Watercourses

The Geological and Hydrogeological Assessment Report states in Section 3 Hydrology, para 3.2 Catchment and Principal Drainage:

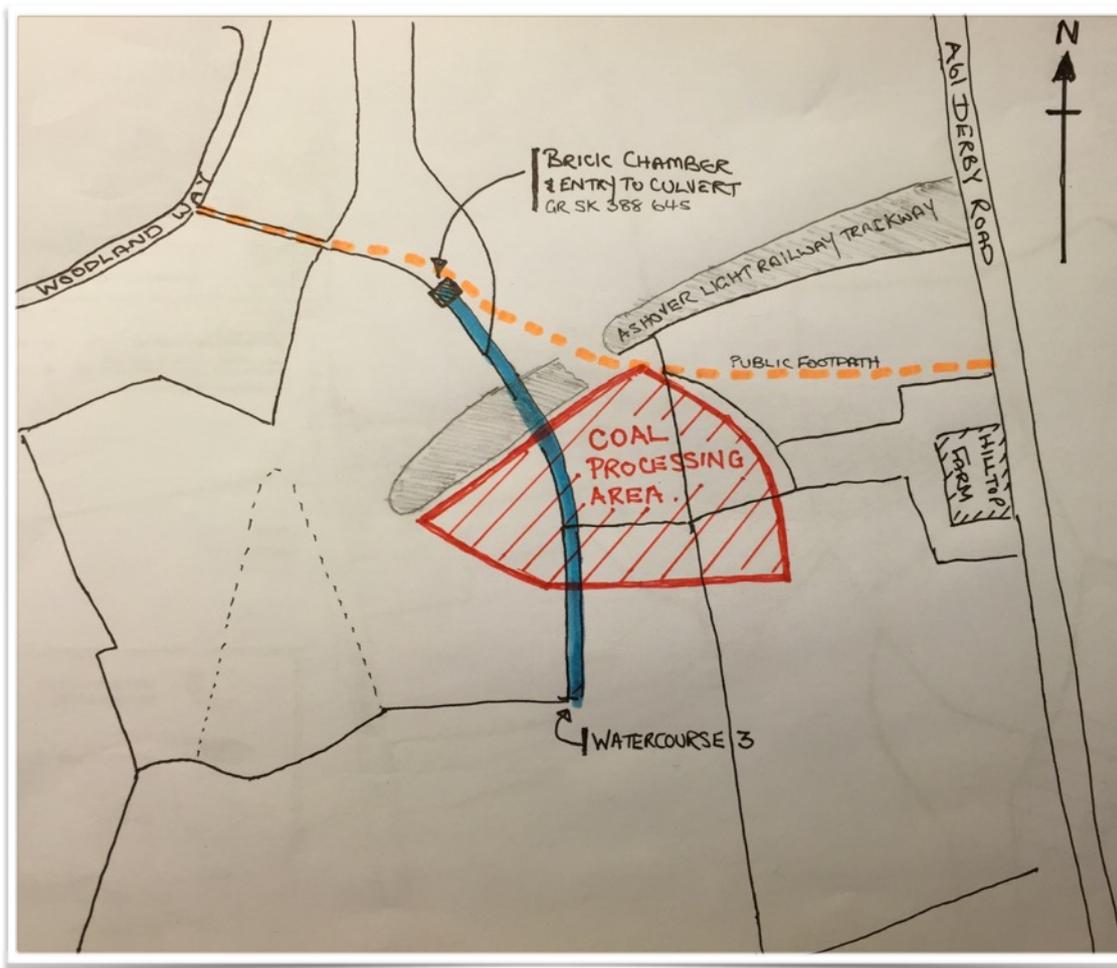
However there is a **third** significant watercourse in the central area of the site to the west of Hilltop Farm.

This stream runs from GR SK 388 642 in a northerly direction, passing through a culvert under the old Ashover Light Railway embankment before finally disappearing into a culvert at GR SK 388 645. The southern section of this watercourse follows the line of Tree Group 26 (p118 ES App6 Ecology).

This watercourse takes the surface water runoff from the proposed coal processing area and adjacent fields. The stream is free flowing, particularly at times of heavy rainfall. The entry to the culvert is a brick chamber approximately 1 metre square capped with heavy concrete slabs. Judging by the volume of water it copes with during the heaviest rainfall, the exit pipe is at least 30 cm diameter.

According to the submitted plans, the coal processing area will obliterate the stream to the south of the Ashover Light Railway trackway. However, as the coal processing area is only to be paved with crushed hardcore the surface will be porous. Surface water runoff from this area will therefore still find its way into the northern stretch of the watercourse and hence into the culvert. This water will be contaminated with coal dust and from the inevitable spillage and seepage of fuel oils.

It is not known where the culvert eventually discharges and therefore where any contaminated water will go.

This watercourse has not been mentioned in the applicant's Flood Risk Assessment or anywhere else in the application documents, showing that inadequate site surveys were carried out.

Until a proper survey and assessment of this watercourse, its catchment area, course and discharge point of culvert are carried out, the consequences of siting the Coal Processing Area over this stream are unknown.

The applicant's Flood Risk Assessment must therefore be considered unacceptable.
